GENESEE COUNTY PLANNING BOARD REFERRALS NOTICE OF FINAL ACTION

T-03-BER-07-24

Site Plan Review and Area Variance for an Approx. 195,000 sq. ft. (Approx. 400 x 500 ft.) new farm equipment manufacturing facility (OXBO) and associated site improvements on existing agricultural land within Appletree Acres Business Park.

**Building Height
Maximum allowed: 35 ft.
Proposed: 42 ft.**

SCALE:	1"=50'
DATE:	May 20, 2024
JOB NO:	M-2405
SHEET NO:	GD-1

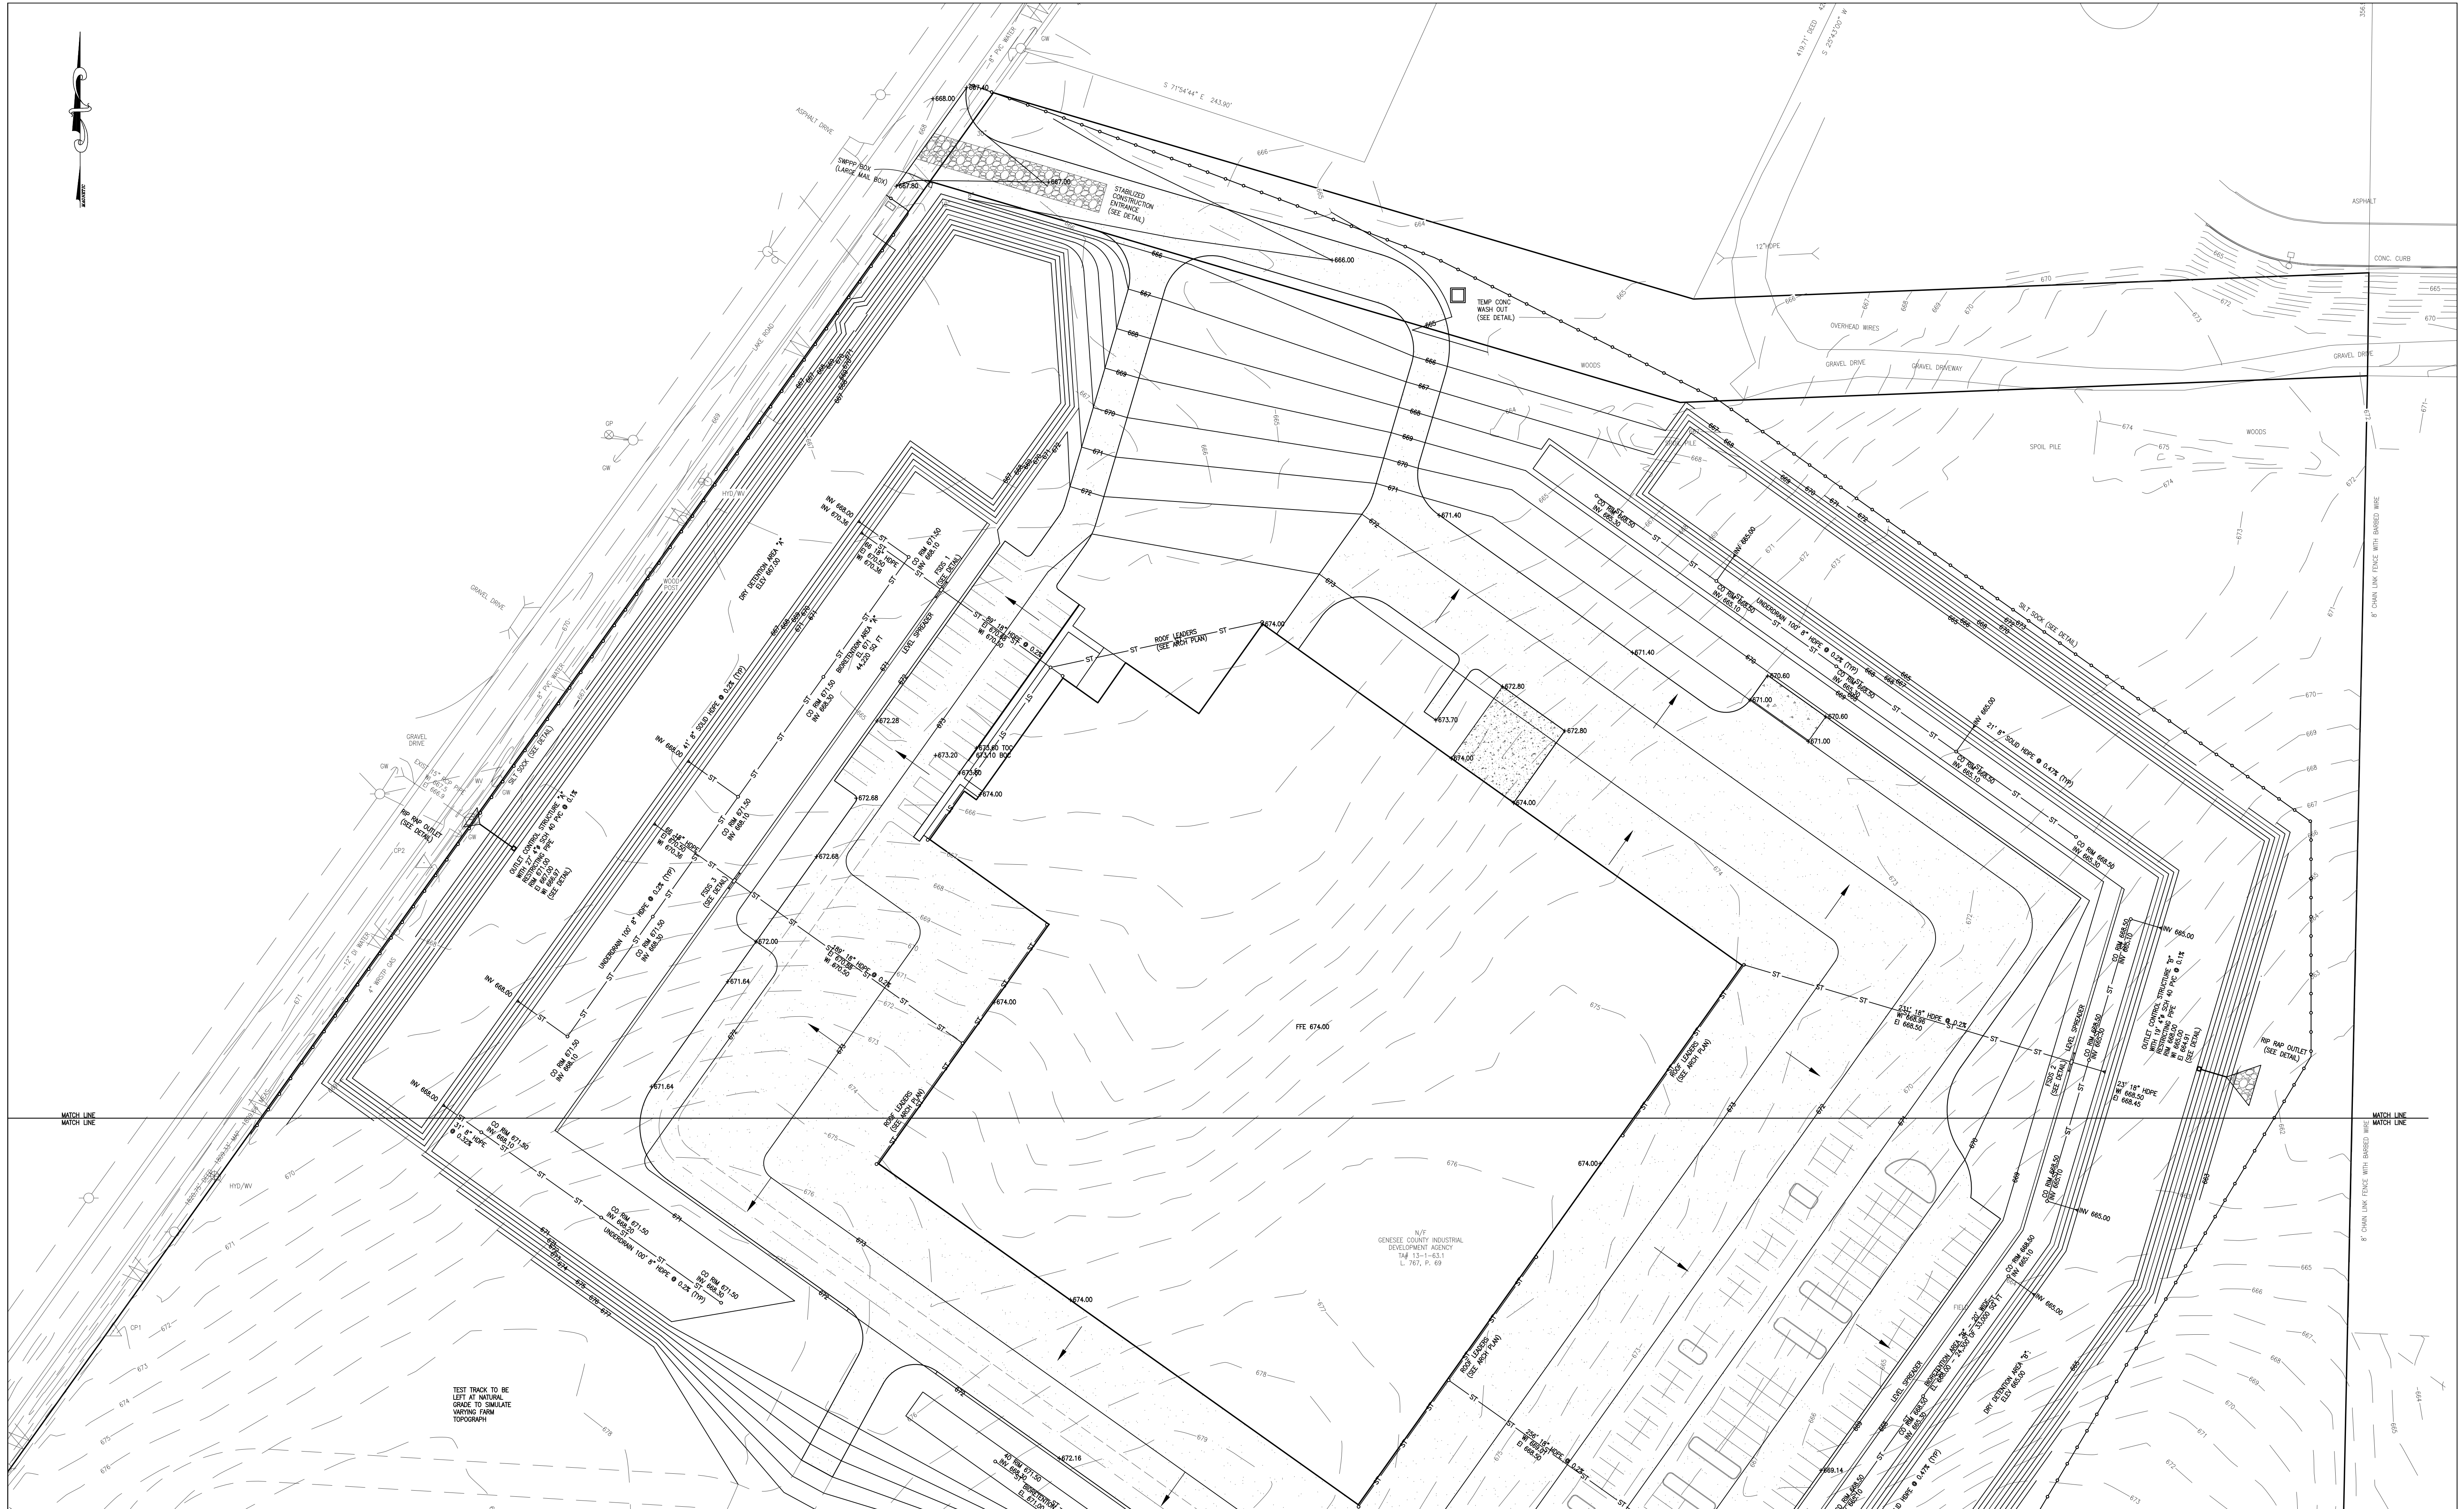
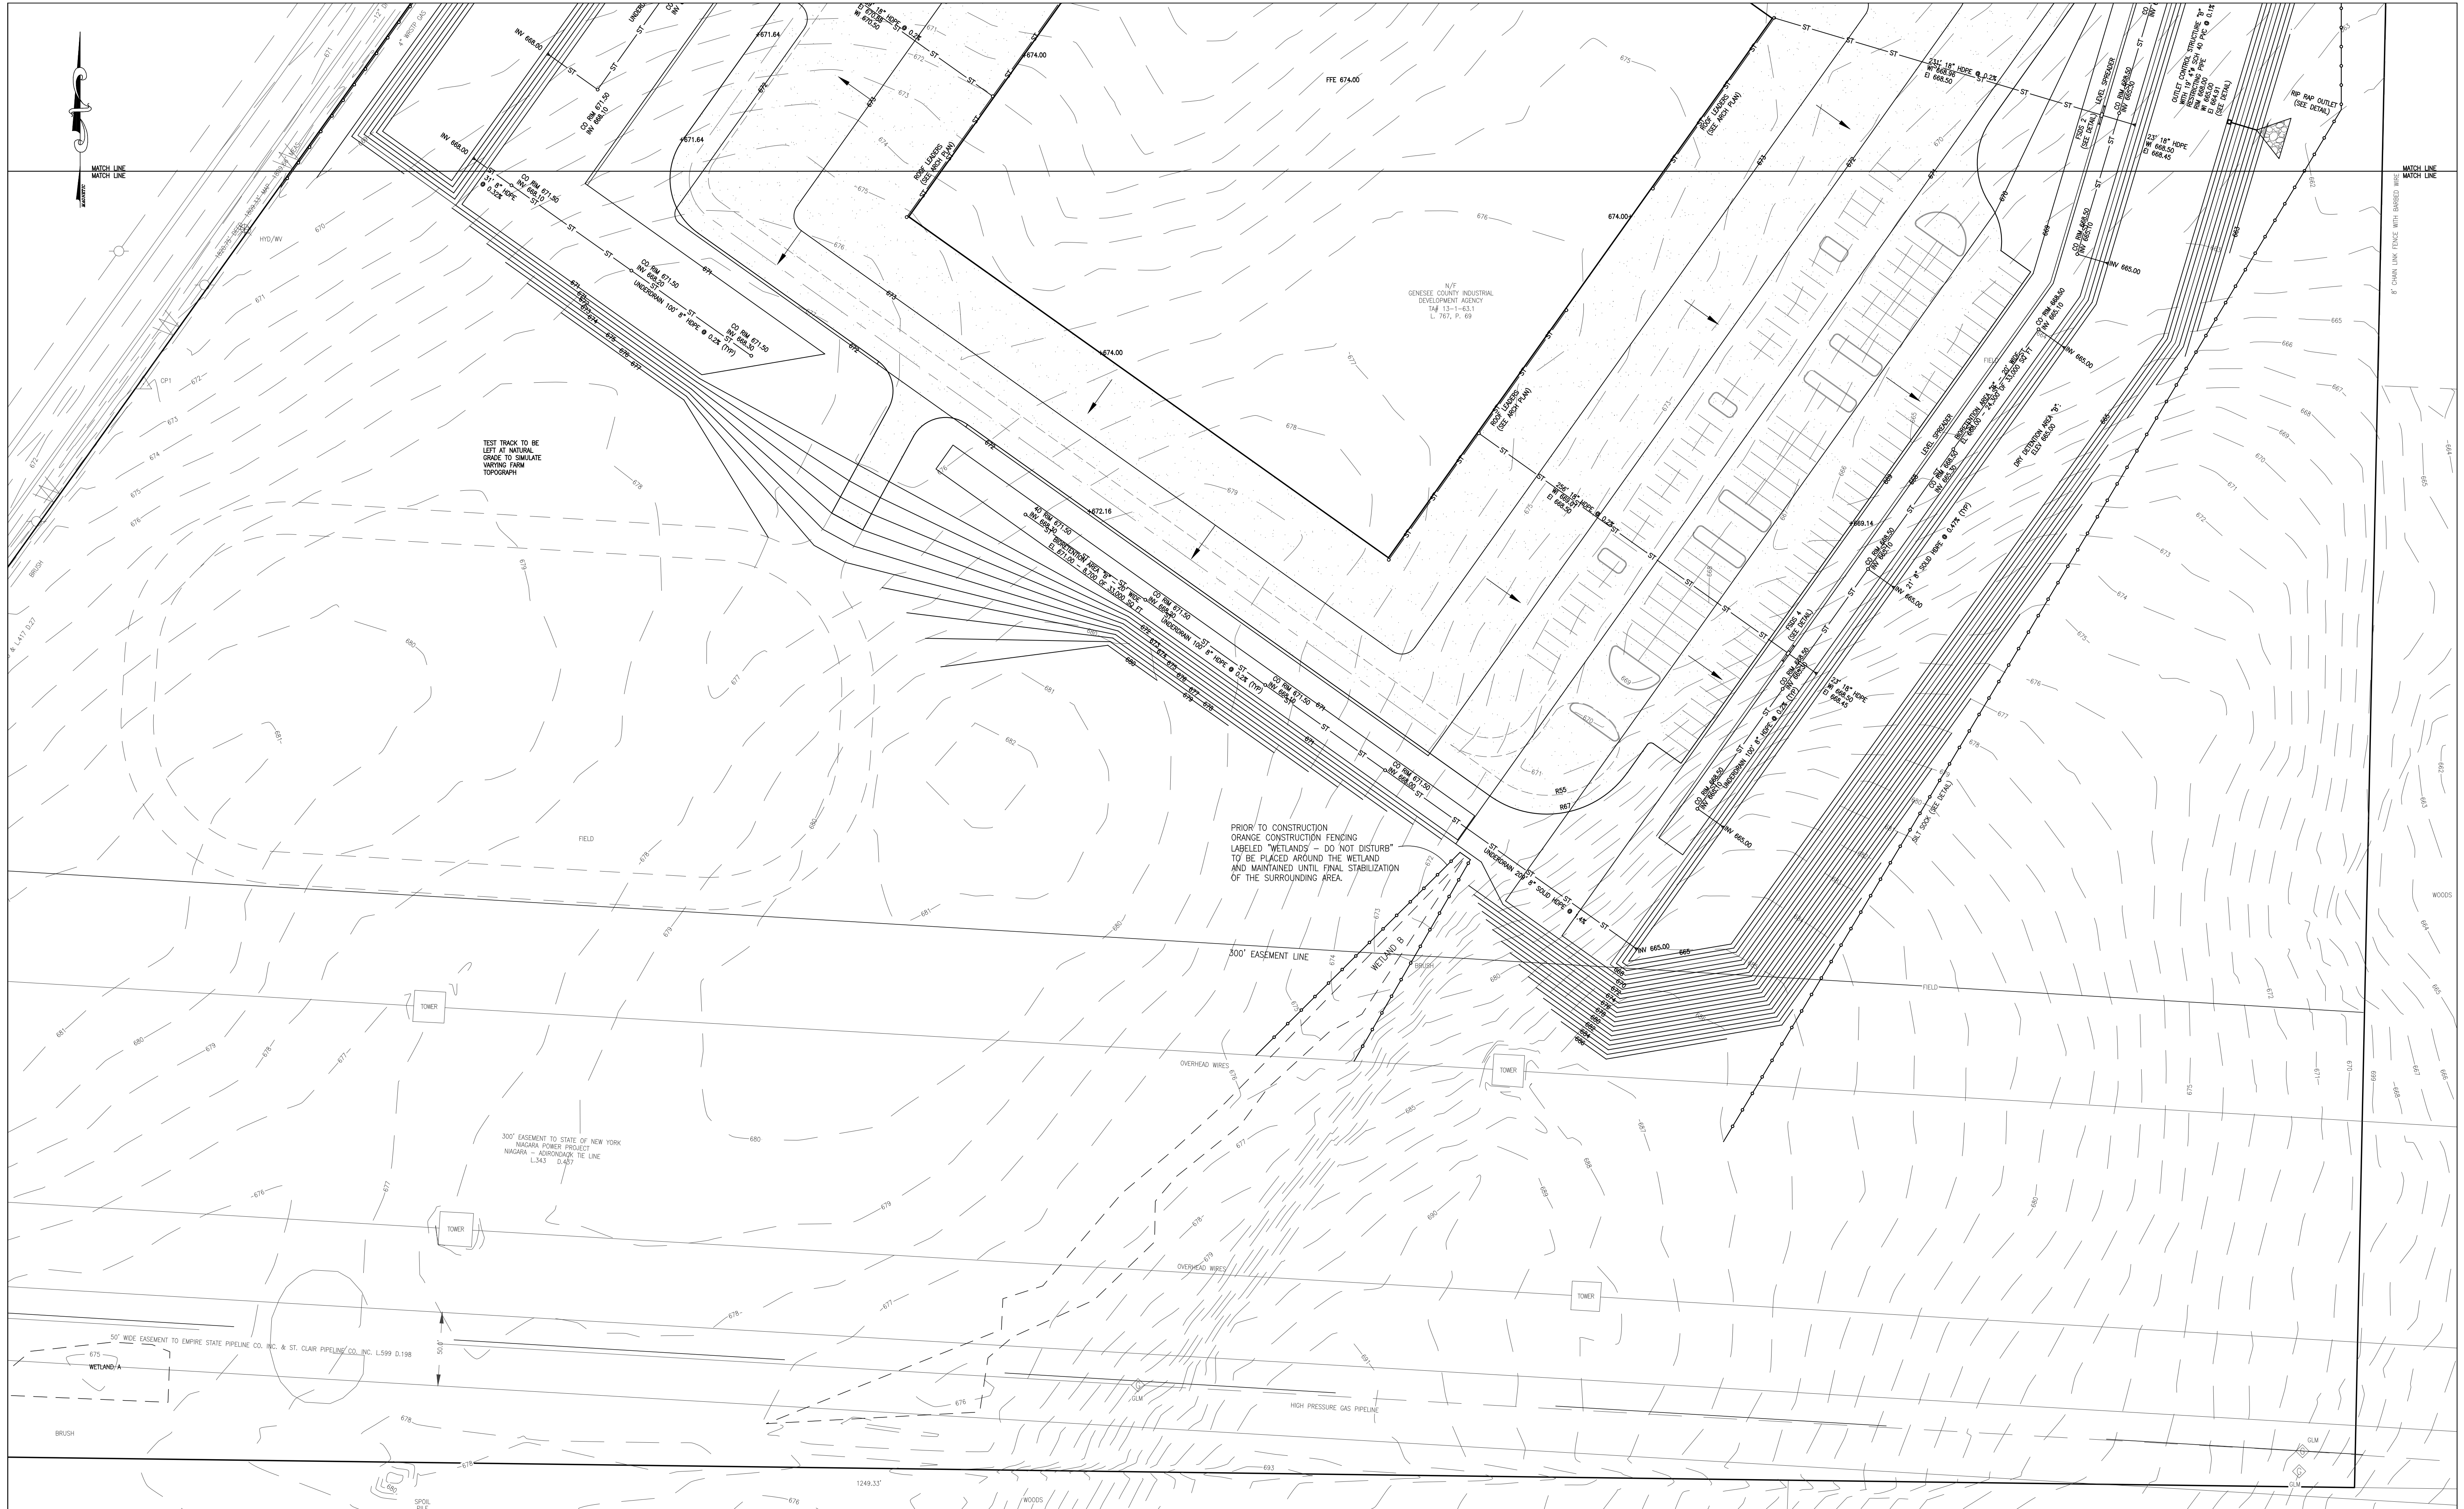
25. The Grading, Drainage, and Erosion and Sediment Control Plans (Sheet GD-1, -2) should show the proposed location of the soil stockpiles (with perimeter control such as silt fence). Additionally, a detail should be provided.

OUTLET STRUCTURES A & B
N.T.S.

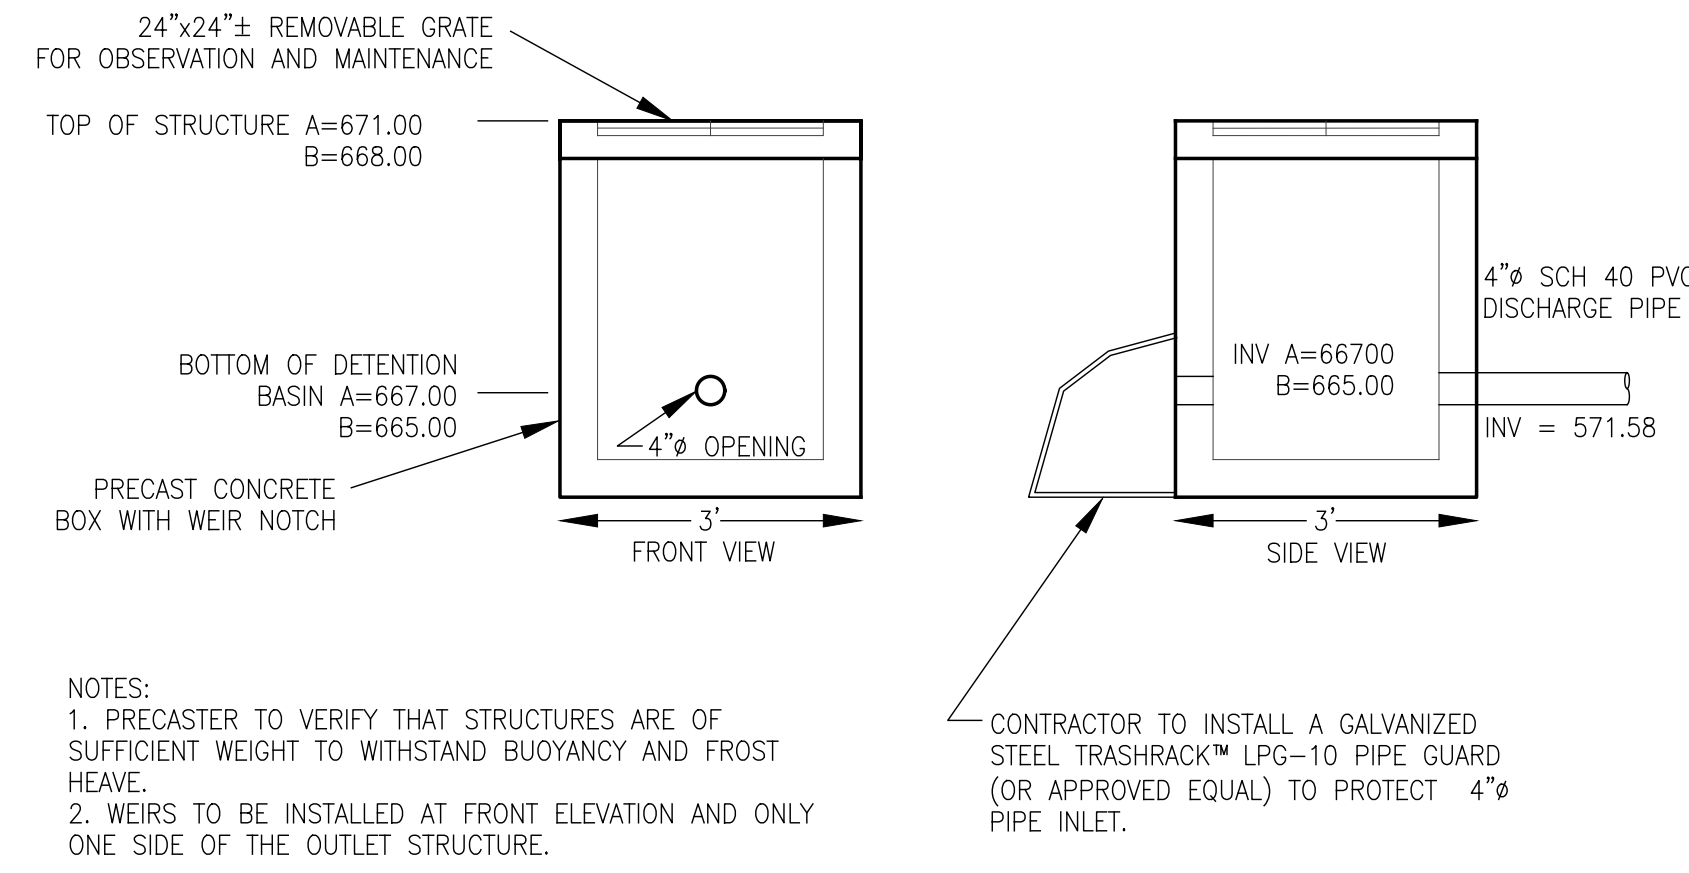
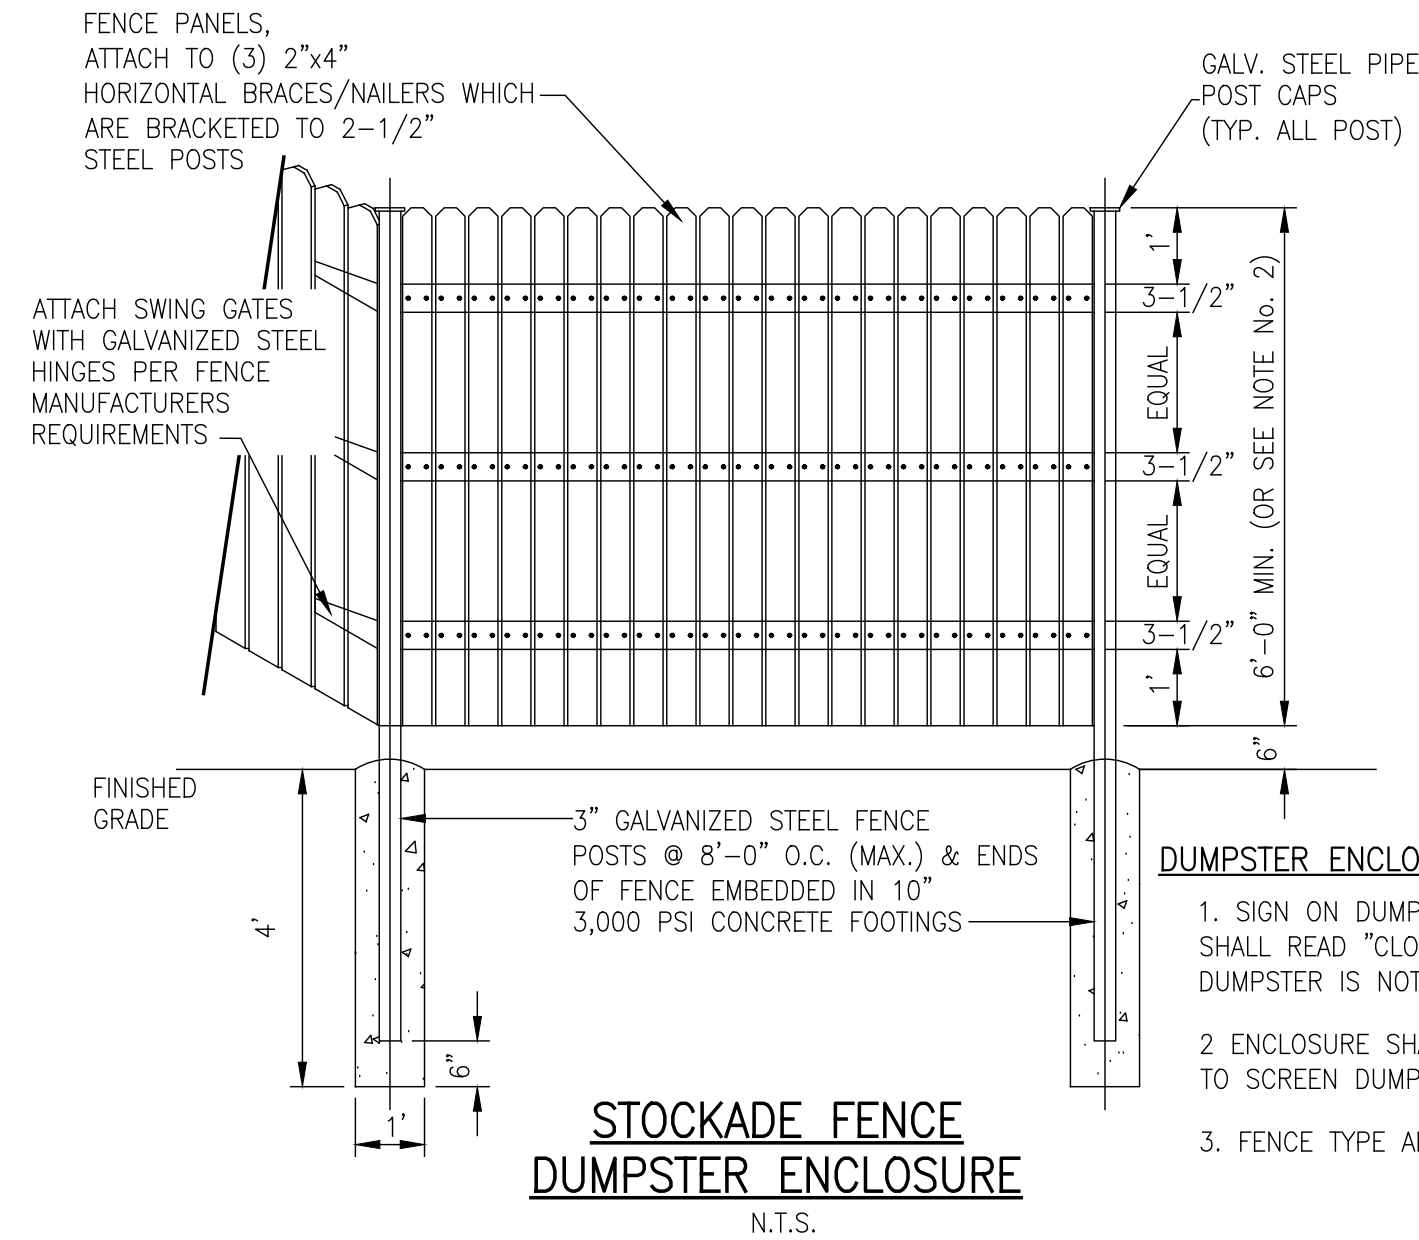
37. Outlet Structures A & B Detail on the Plans (Sheet DT-1) – remove label "Inv = 571.58" from the detail as it appears this is not relevant to this drawing.
